Date: March 31, 1994  
 From: Tom Hanan, Western Digital  
 Updated by: Steve Finch for presentation to X3T10 Plenary  
 TO: X3T10 ATA Working Group and SFF ATAPI Project Group  
 Subject: Updated Mode 4 16.6 MB/s timing for ATA-2

FIGURE x-1 MULTIWORD DMA TIMING DIAGRAM

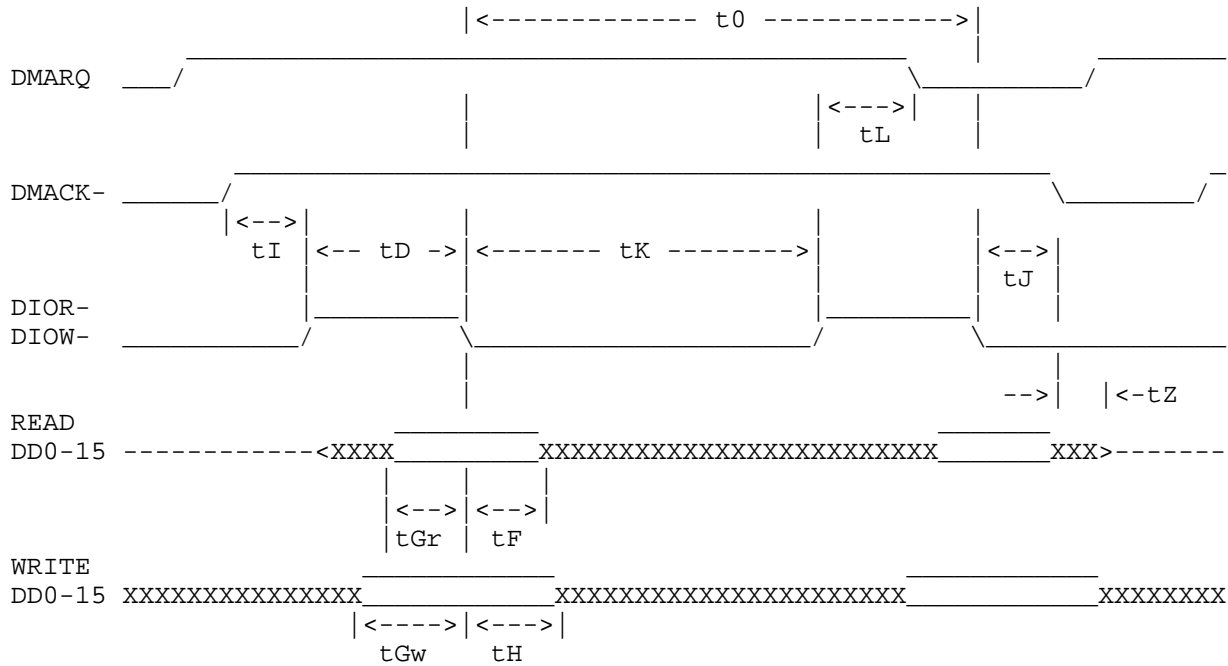
The timings associated with Multiword DMA Transfers are defined in Figure x-1, and include the new timing parameter tZ. The minimum value of t0 is specified by word 65 in the Identify Drive parameter list. Note that the edge used to measure T0 was changed from asserted to de-asserted in order to make the timing diagrams more closely reflect real VLSI and system timing issues.

FIGURE x-2 PIO TIMING DIAGRAM

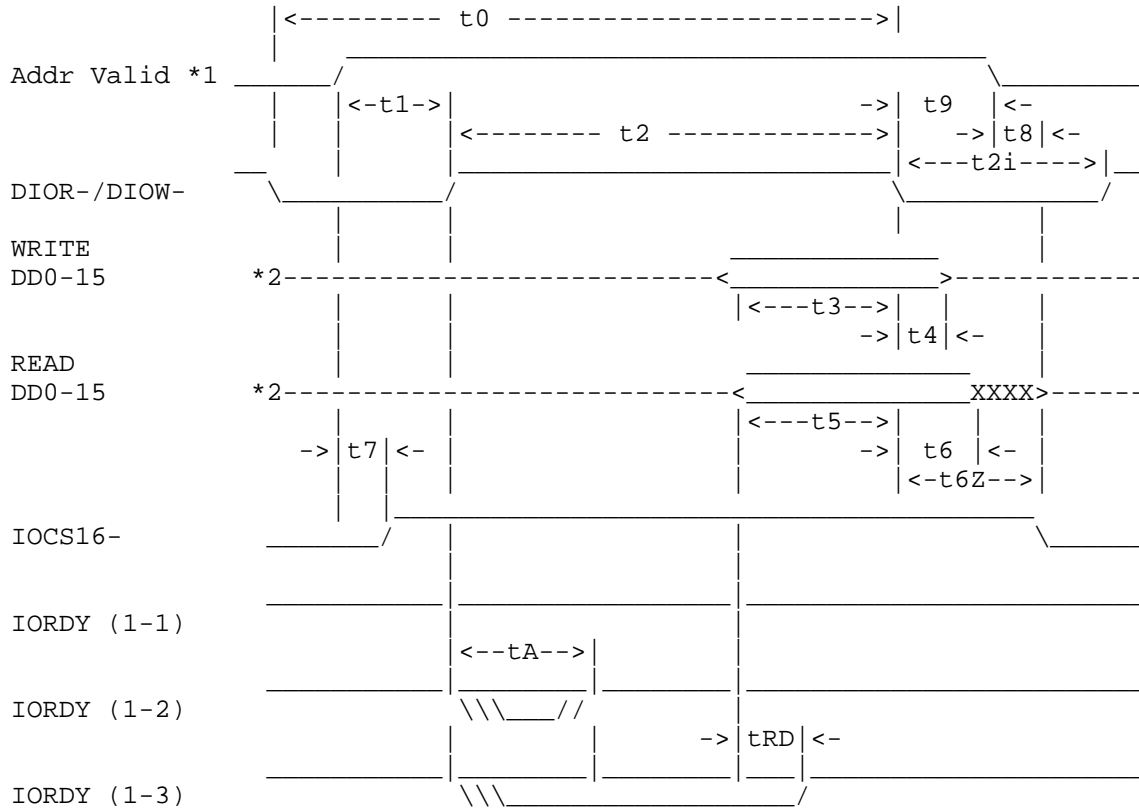
The timings associated with PIO Mode 4 transfers are defined in Figure x-2, and include the new timing parameters  $t_{2i}$ ,  $t_{6Z}$  and  $t_R$ . The minimum value of  $t_0$  is specified by word 68 in the Identify Drive parameter list (see 7.1.8). Note that the edge used to measure  $T_0$  was changed from asserted to de-asserted in order to make the timing diagrams more closely reflect real VLSI and system timing issues.
